Subject: Evaluation of South Tampa Stormwater Project
Tampa, Florida

August 1, 2026

Prepared by: Martin E. Millburg, P.E.
2414 West Watrous Avenue
Tampa, Florida 33629

ENGINEERING REVIEW OF SOUTH HOWARD STORMWATER PROJECT

Figure 6-3 – Recommended Alternative Profile View and 100-year/24-hour HGL Comparison

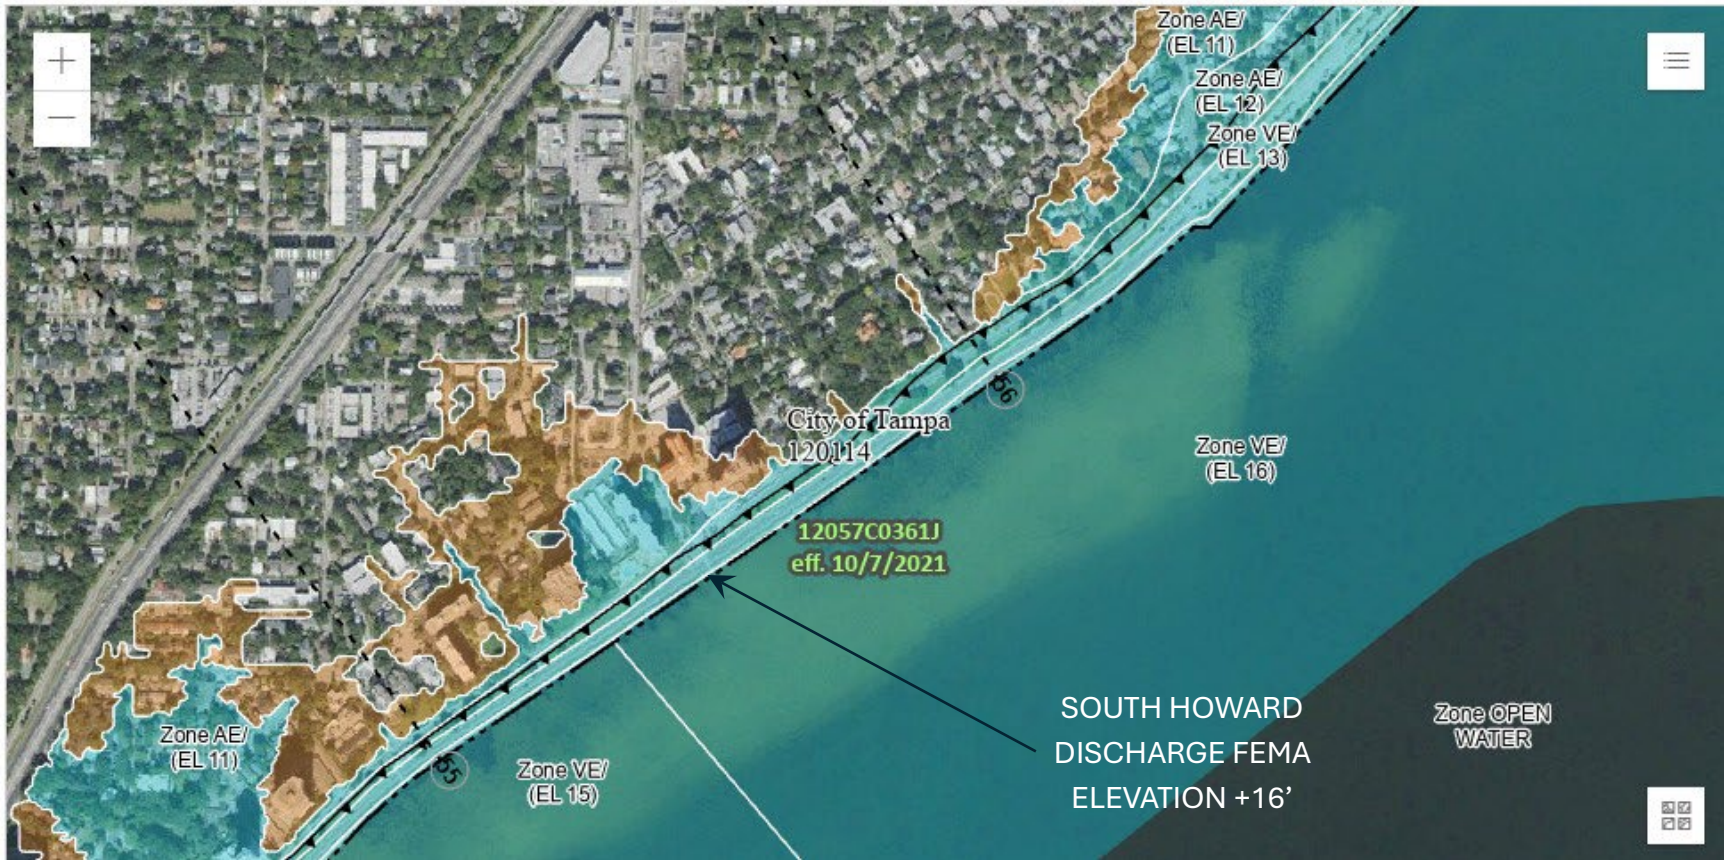
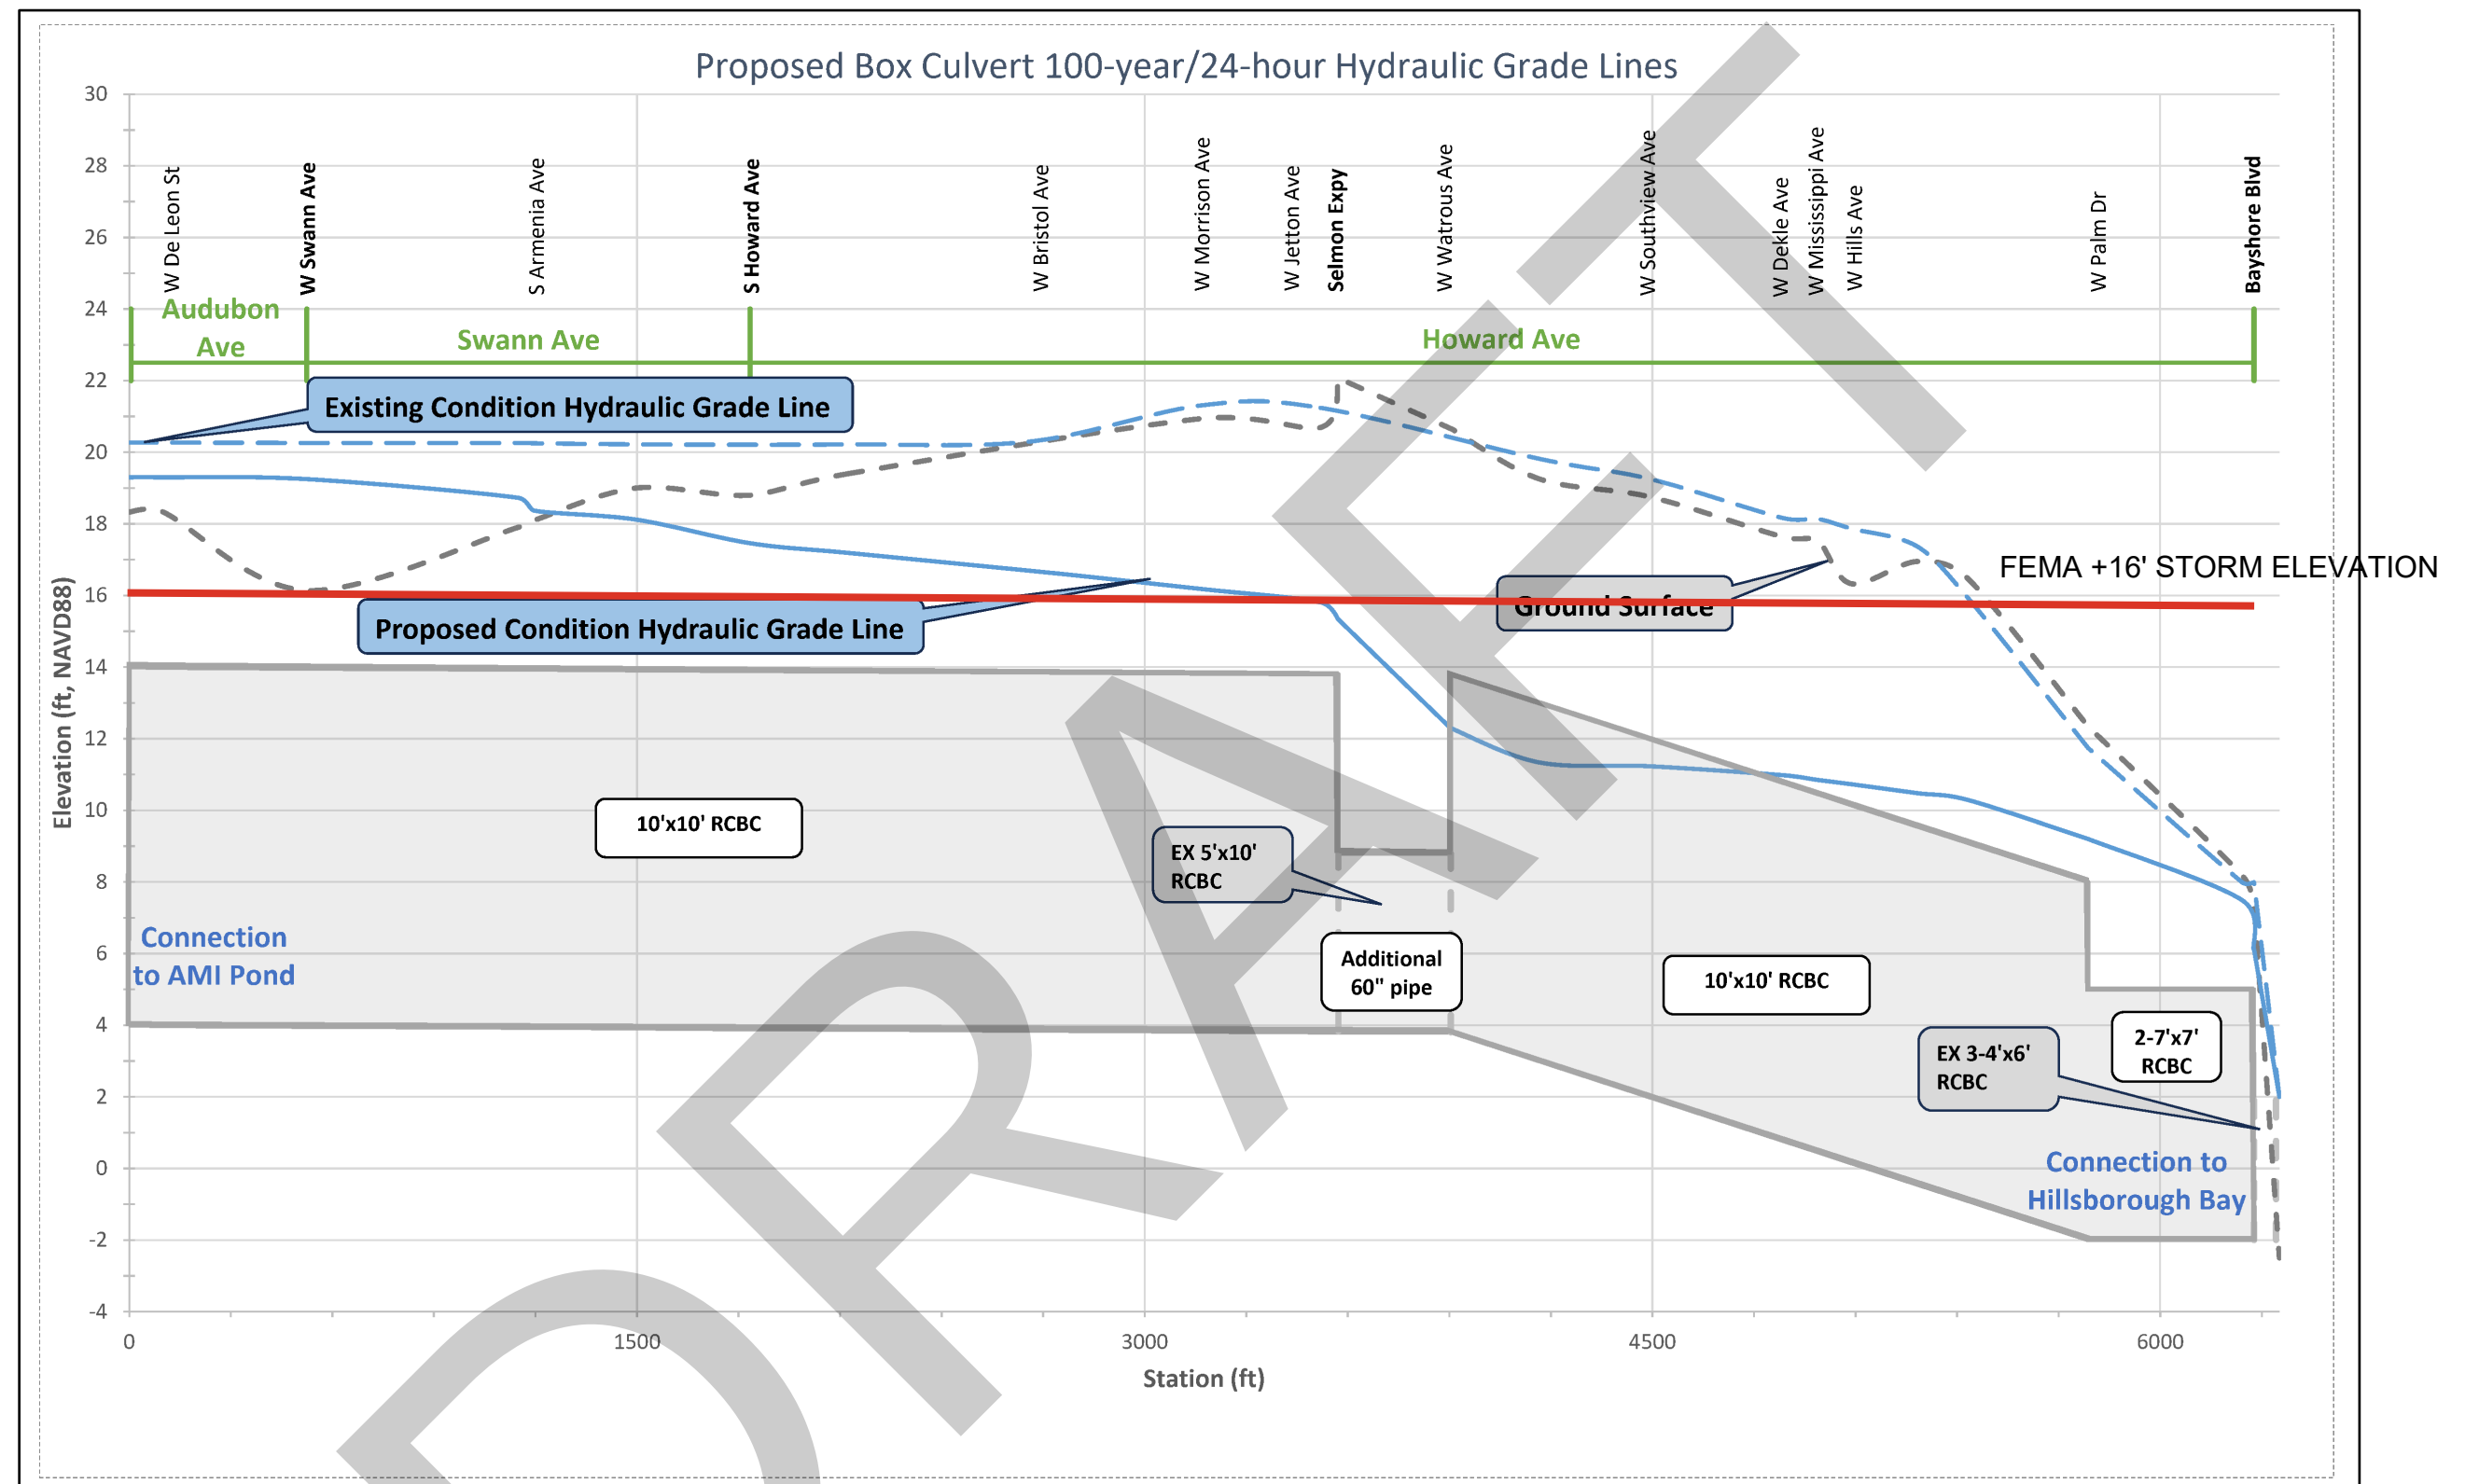
9. During a major storm event when effective drainage is most needed, the effectiveness of the gravity drainage system will be dramatically reduced. A 6,000 feet long gravity based drainage system depends on significant differential head between along the system. Using the 20.5' flood elevation shown for a Hurricane Milton event, a FEMA defined storm event that raises the tailwater elevation as high as +16' reduces flowrates by about 2/3 as the tailwater elevation rises from +8' to +16'.

- 9) Gravity System Failure During a Storm Event** – For the proposed Milton storm event, the hydraulic grade shows the headwater as high as +20.5' with a tailwater elevation of about +8'. This provides about 12.5 feet of driving head. If the FEMA storm elevation of +16' is present at the tailwater, the resulting driving head is reduced to 4.5 feet. Stormwater flow through the gravity system would be reduced by about 2/3 during the time at which it is most needed.
